ADDENDUM 01

Date: April 24, 2026

Project: RFB-458 Fairmont State University Musick Library Modernization

title
PIPING - FIRST FLOOR PLAN - PLUMBING

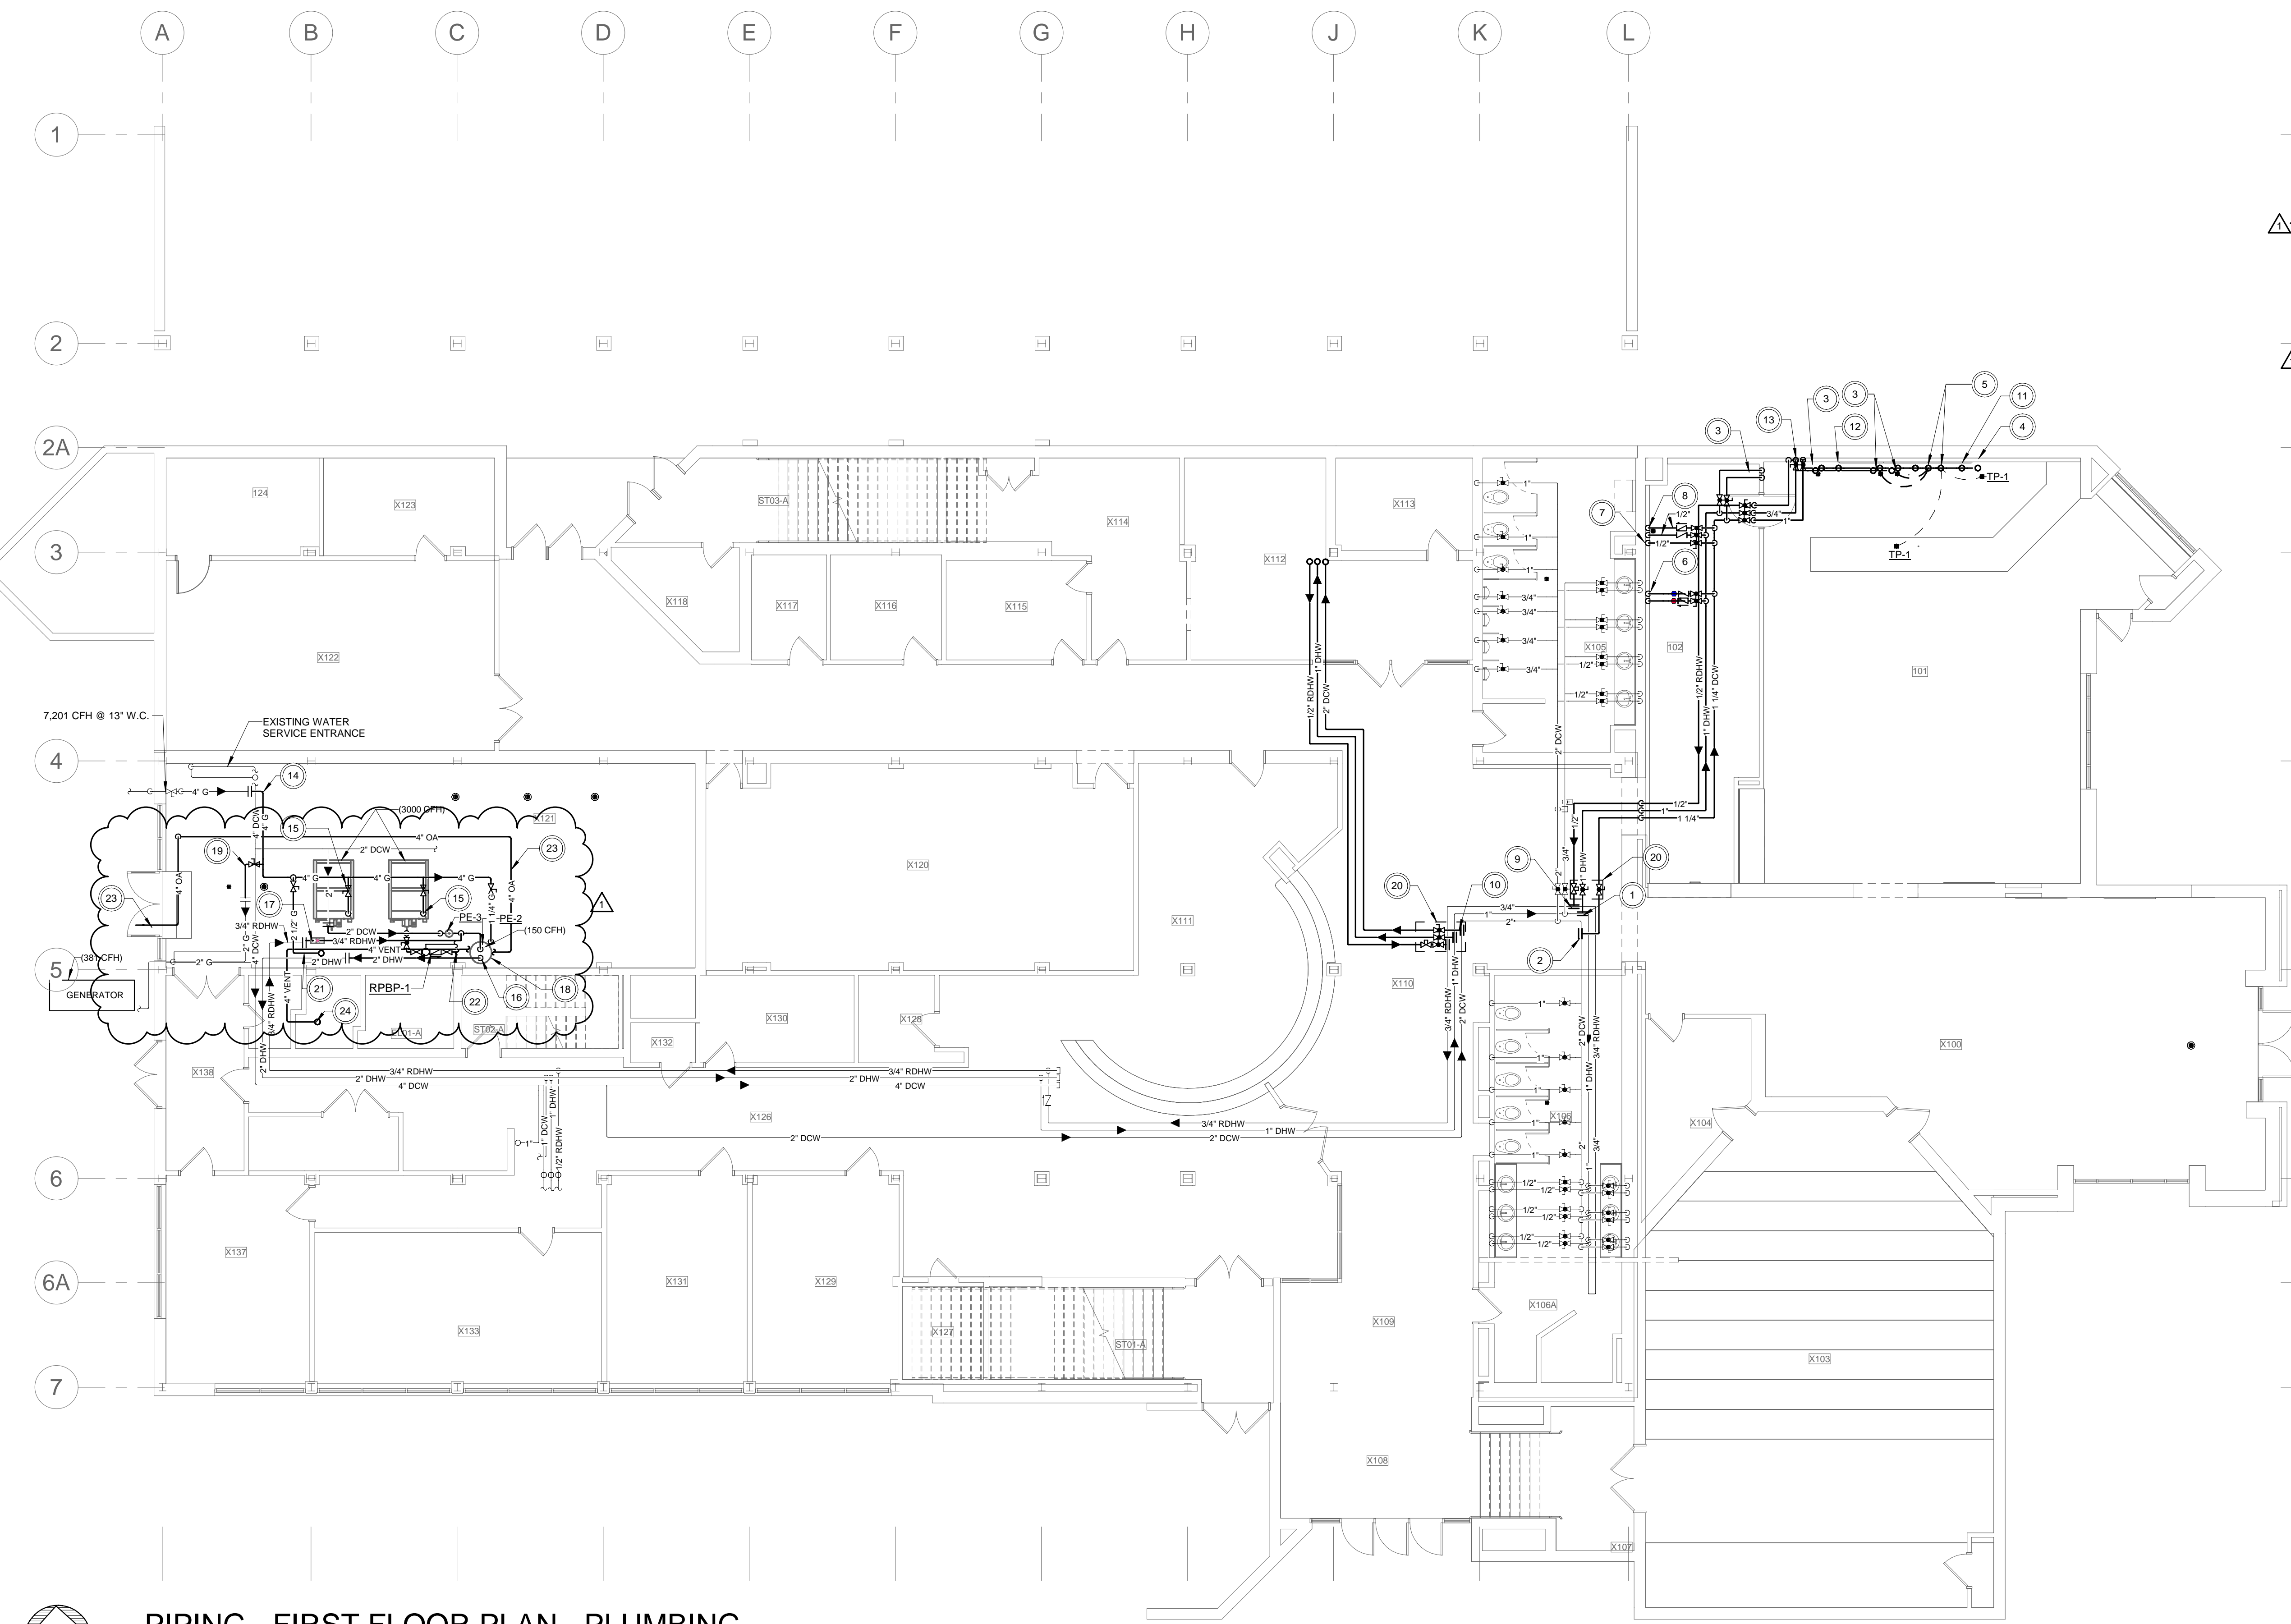
1. Sheet P3.1 PIPING – FIRST FLOOR PLAN – PLUMBING
 - a. Revised coded note 18.
 - b. Added coded notes 23 and 24.
 - c. Added 4" combustion air and vent piping for water heater.

- d. Revised gas loads and piping
2. Sheet P3.2 PIPING – SECOND FLOOR PLAN – PLUMBING
 - a. Added vent piping serving water heater.
3. Sheet P3.3 PIPING – THIRD FLOOR PLAN – PLUMBING

- EXTEND 4" COMBUSTION AIR FROM WATER HEATER OUT INDICATED EXTERIOR WALL AND INSULATE. TERMINATE WITH 45 DEGREE ELBOW DOWN.
 - EXTEND 4" VENT PIPING FROM WATER HEATER AND ROUTE WITHIN CHIMNEY SPACE AND EXTEND TO ROOF.

title
 PIPING - THIRD FLOOR PLAN - PLUMBING

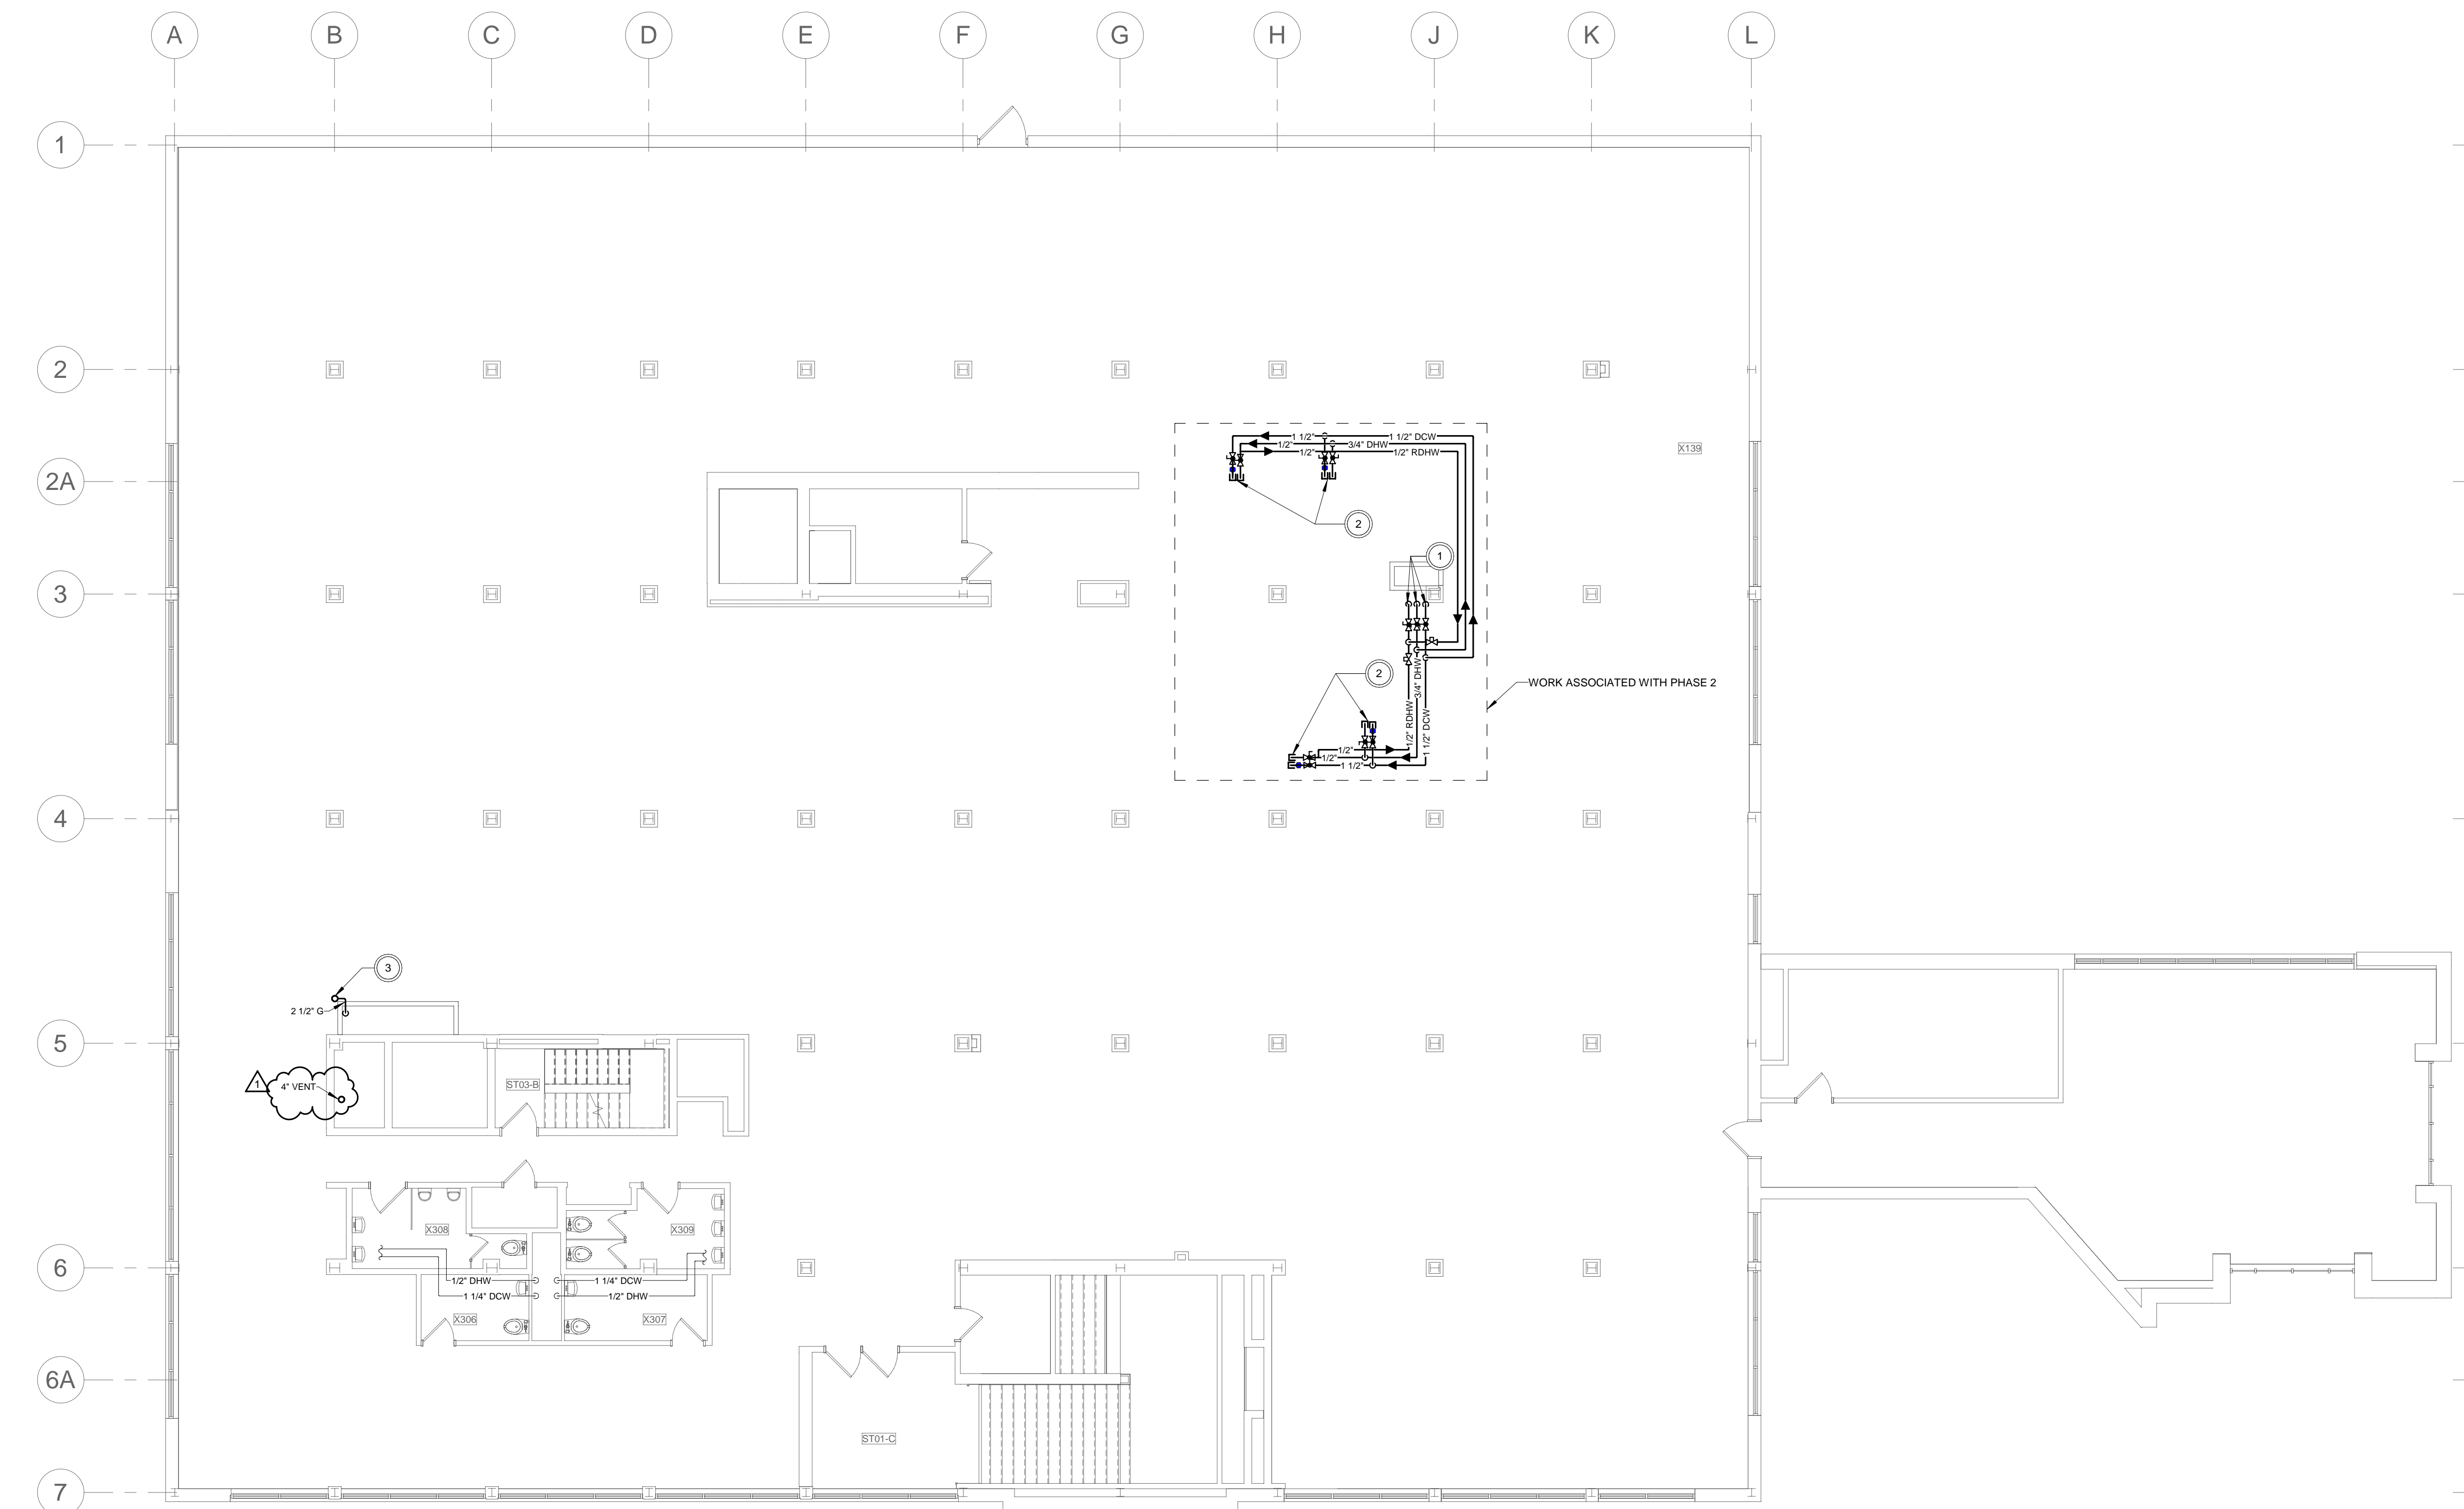
- a. Added vent piping serving water heater.
4. Sheet P3.4 NEW WORK – ROOF PLAN – PLUMBING
 - a. Added vent piping serving water heater.
 - b. Added coded note 5.
